Ground Water Review Form:

Application: T-12227

Applicant Name: Stephany Moody

Proposed Changes: POA APOA SW→GW RA
 USE POU OTHER

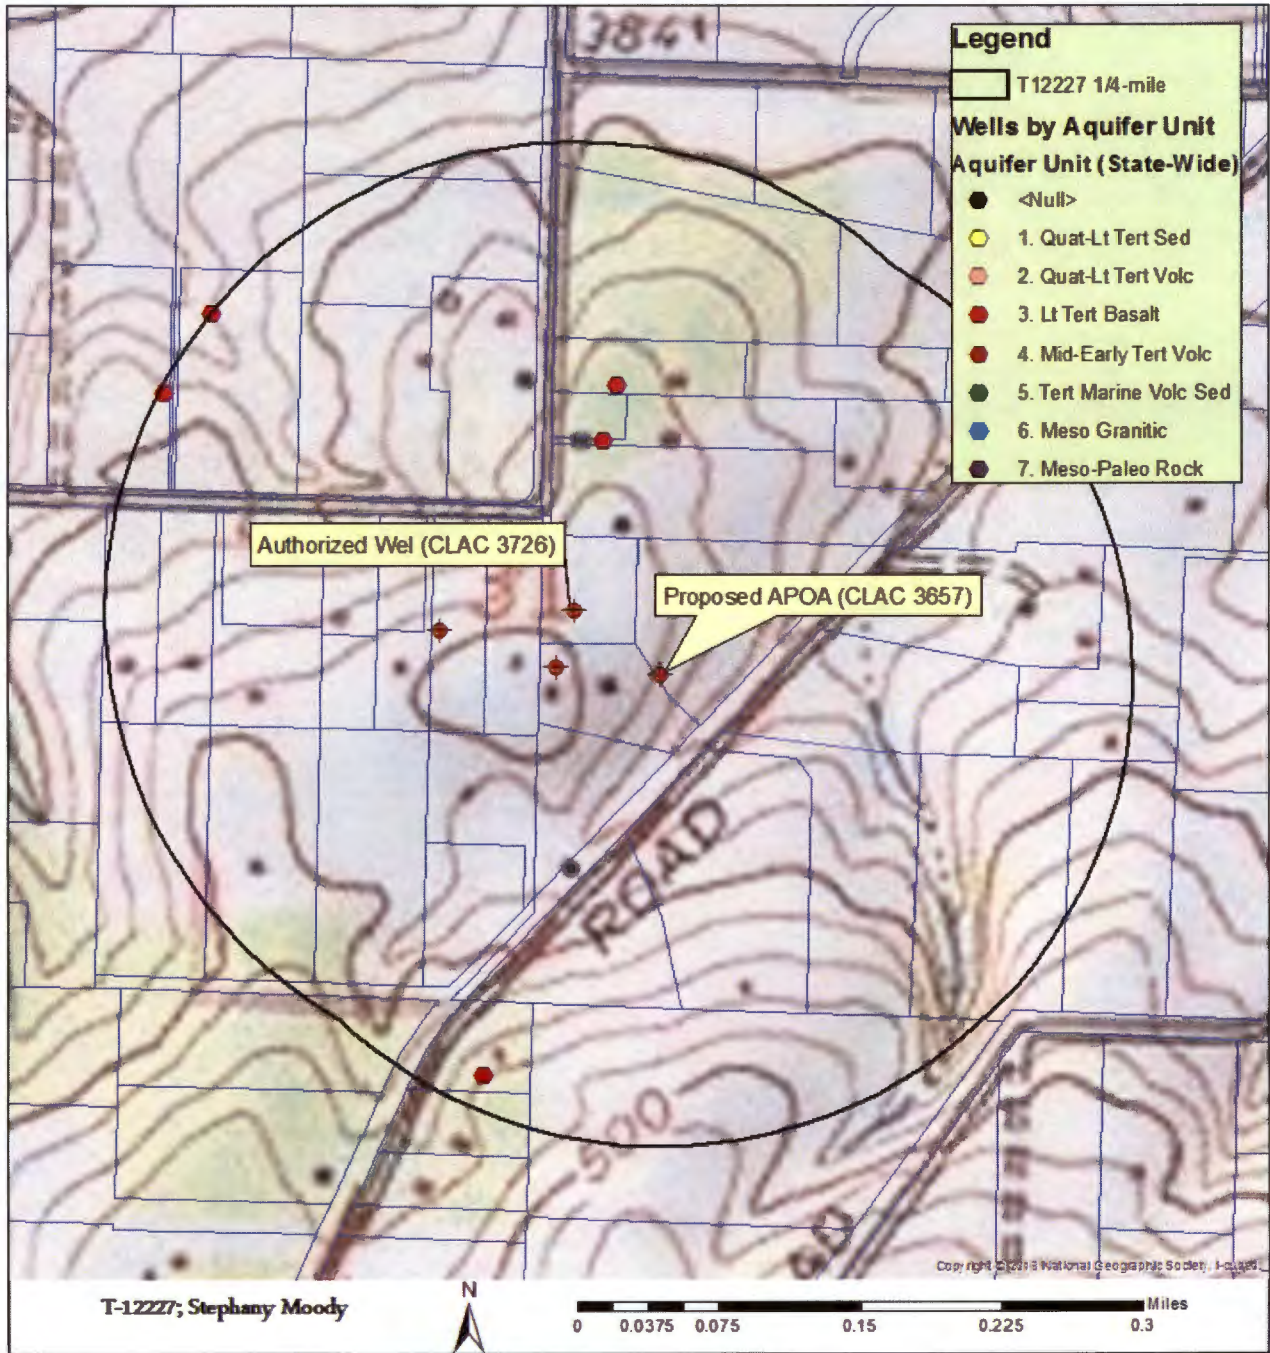
3. a) Is there more than one source developed under the right (e.g., basalt and alluvium)?
 Yes No Both wells are producing from a basalt aquifer. Based on the limited available static water level data I cannot positively state that the wells are producing from the same basalt aquifer.

7. Any additional comments: In the Sherwood-Dammasch-Wilsonville Groundwater Limited Area, the basalt aquifer system consists of stacked, tabular aquifers which were in decline. This trend has largely turned around with the cessation of pumping from the Wilsonville basalt aquifer wells. Given the limited data (static water levels from the well log and approximately 2 years of quarterly water levels at CLAC 3726, and a single static water level from the well log for the proposed well (CLAC 3657)) I cannot determine that these wells are producing from the same aquifer.

6. What conditions or other changes in the application are necessary to address any potential issues identified above: **If the applicant wishes to contest this finding, they can conduct a well interference test. The test should be designed and conducted by an Oregon Registered Geologist, and the test design should be subject to the approval of the Groundwater Section of the Department prior to the test. At a minimum, the test should include discharge and water-level measurements in the pumping well and simultaneous water-level measurements in the other well. If practicable, water-level measurements should also be made in nearby wells. The results of the aquifer test should be presented in a report to the Department that includes an analysis of aquifer properties, and aquifer boundaries. The Department must find the report(s) acceptable before this finding could be reversed and use at the APOA could be approved.**
